EPA Response to Comments

Response to Public Comments

**Class III Area Permit No. SD31231-00000, Aquifer Exemption Decision
And
Class V Area Permit No. SD52173-00000**

**Powertech (USA) Inc.
P.O. Box 448
Edgemont, South Dakota 57735**

Figure U. Pass Creek alluvium cross-section and the Burdock Area Pond locations for the land application disposal option.

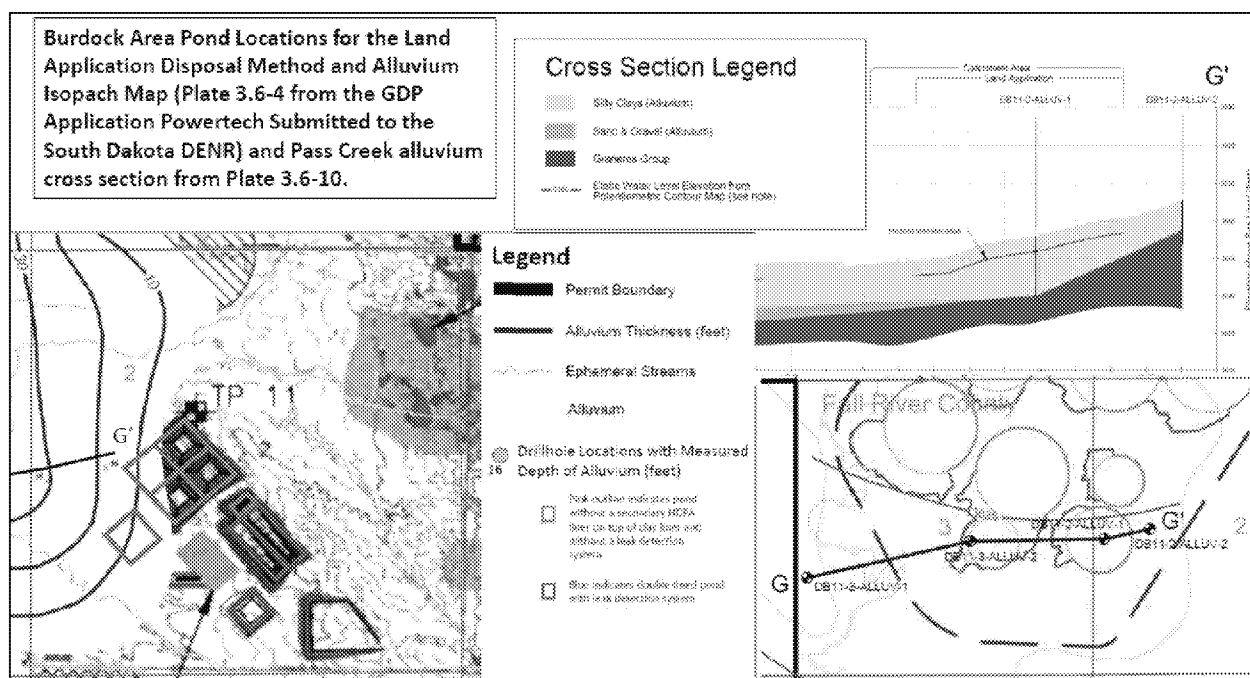
EPA does not agree with Powertech about the potential impacts from a pond leak in this area. EPA performed an analysis of the geological conditions underlying the Burdock Area Ponds to evaluate impacts from the potential leaking of ponds. EPA has concerns that although the ISR waste fluids would have been treated to remove radium, the stored water would still contain byproduct material and high TDS reject water from the reverse osmosis treatment system. Leaking from ponds in this area have the potential to affect alluvial aquifers. Plate 3.6-10 in the Groundwater Discharge Permit Application shows cross-sections of the Pass Creek alluvium and Appendix 3.6-A contains logs from Pass Creek alluvial

Because of EPA's concern about potential effects to these alluvial aquifers, EPA included a condition in Part II, Section I.4.a of the Class III Area Permit requiring the Permittee to submit information to the EPA Region 8 Air and Radiation Division to determine the applicability of the 40 CFR part 61, subpart W regulations, and if necessary, receive construction approval from EPA. If CAA subpart W applies to these ponds, Powertech will need to meet subpart W requirements. The surface impoundment design, construction, and operating requirements are found under 40 CFR § 264.221(c) which requires two or more liners, installation of a leak detection system, and a leachate collection and removal system between such liners.

Figure V. Burdock Area Land Application Area and proposed Perimeter of Operational Pollution (Sources: Groundwater Discharge Permit application Figure 6.1-3 and Class III Permit Application Plate 6.12)

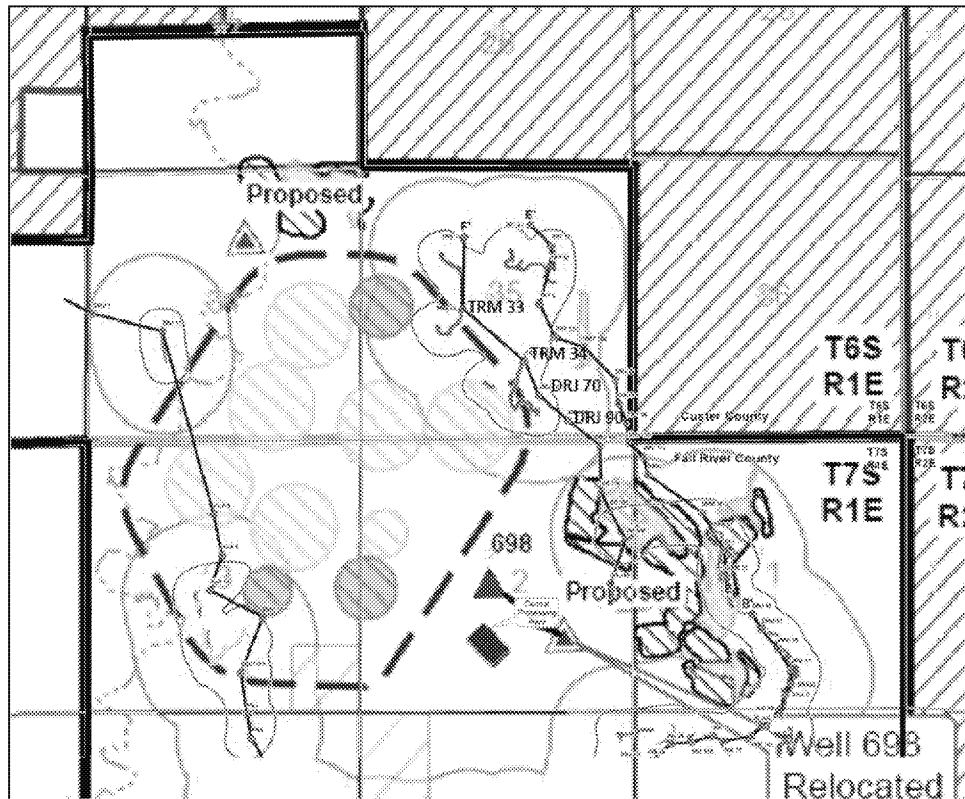
EPA reviewed drillhole data along northeastern POP boundary in the Burdock Area. Figure V shows the Burdock POP boundary from Groundwater Discharge Permit application. Figure 6.1-3 contains an excerpt from Plate 6.12 of the Class III Permit Application showing available cross-sections in the Dewey-Burdock Area. According to Class III Permit Application Plate 6.18 Cross-Section F-F', logs of drillholes TRM 33 and TRM 34 show 10 feet of Graneros Shale. Because the Graneros Shale has been eroded away in this area, logs of drillholes DRJ 70 and DRJ 90 show the Graneros Shale is absent above the Fall River Formation. Because these drillhole locations are located outside the POP boundary, they do not necessarily indicate the Graneros is less than 25 feet thick within the land application areas. Groundwater Discharge Permit application Plates 3.6-9 Cross-Section E-E' and Plate 3.6-8 Section D-D' show that the Graneros shale is 25 feet or more within the land application areas. Cross-Section F-F' in Plate 6.12 of the Class III Permit Application also shows that the Upper Fall River is not saturated at the locations of drillholes TRM 34, DRJ 70 and DRJ 90. Powertech proposes vadose zone monitoring at catchment areas (which are shown in Figures 6.1-2). EPA considered whether monitoring wells should

be completed in the Fall River aquifer at the northeastern POP boundary and determined that the catchment area vadose zone monitoring at the northeastern edges of the Burdock land application area will also serve as monitoring for the Fall River aquifer in this area. In addition, the Upper Fall River aquifer monitoring wells associated with Burdock Wellfield 8 will also provide monitoring for TDS, specific conductance, and alkalinity at the northeastern POP boundary.

Figure W Projected Construction, Operation and Decommissioning Schedule (Source: Figure 10.2 in the Class III Permit Application.

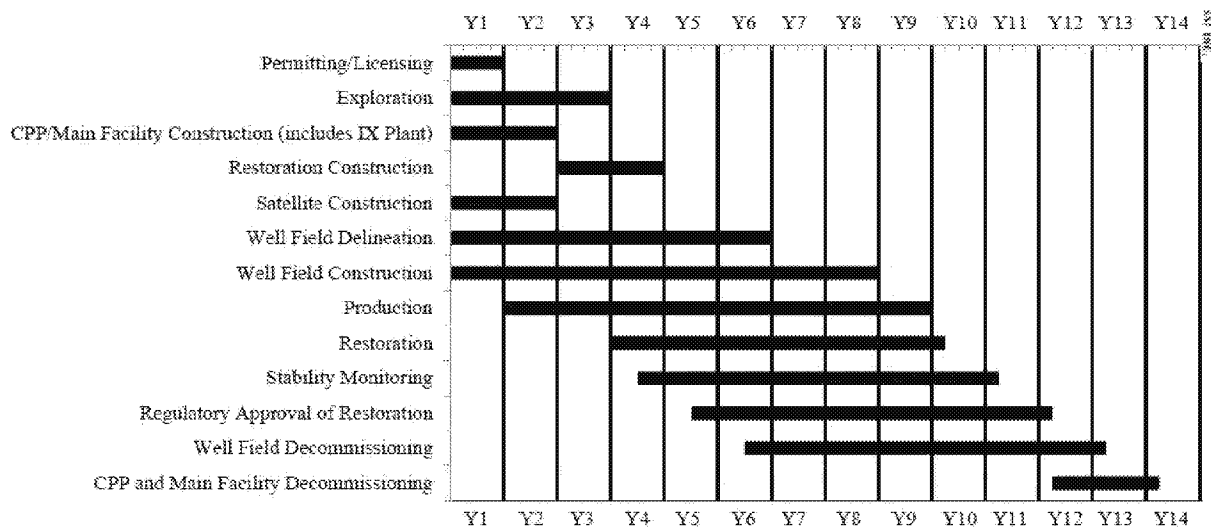
The Class III Permit Application includes the project timeline in Figure W showing an estimated life of the project to be 14 years. Not all 14 wellfields will be in operation at the same time, because Powertech plans to initiate wellfield phases (construction, operation, restoration, closure and decommissioning) sequentially for each wellfield. Figure X shows an example of this sequential approach for Burdock Wellfields 1 through 10.

Figure 3.2-6: Overall Process Flow Diagram

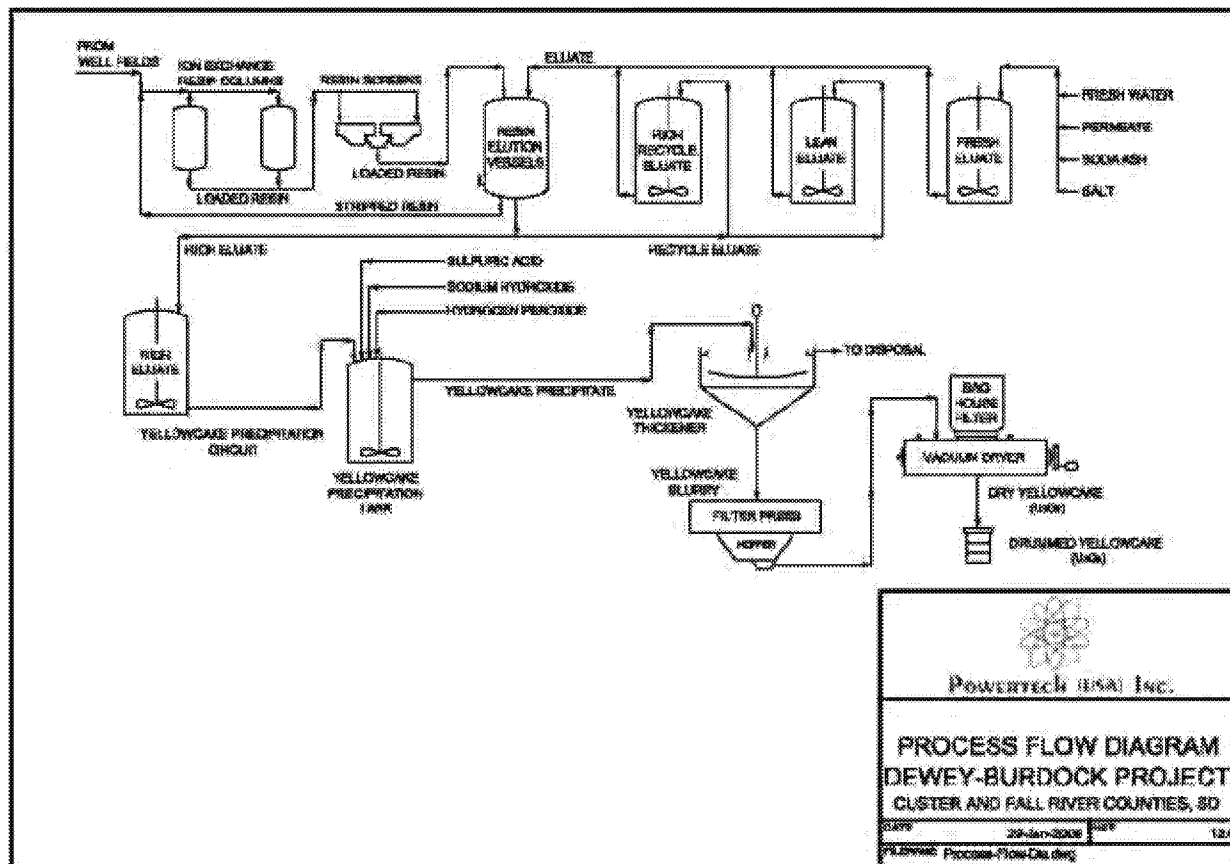
361. Powertech raises a comment regarding the statement in the CEA that Powertech proposes to store, use, and receive shipments of anhydrous ammonia (NH₃). According to Powertech, it does not propose to use ammonia at the Dewey-Burdock Project. Powertech refers to Figure 3.2-6 in the approved NRC license application and explains that it shows that sodium hydroxide will be used in the precipitation circuit instead. Powertech also refers to Table 3.2-1 in the approved NRC license application, which lists the process-related chemicals and quantities planned for the project, likewise does not include ammonia. Powertech requests removing mention of anhydrous ammonia from this paragraph.

EPA agrees with Powertech's comment and has updated the two references to "anhydrous ammonia" (NH₃) in the CEA Section 12.2, and instead replaced them with sodium hydroxide. We have included Figure 3.2-6 in the approved license application here.
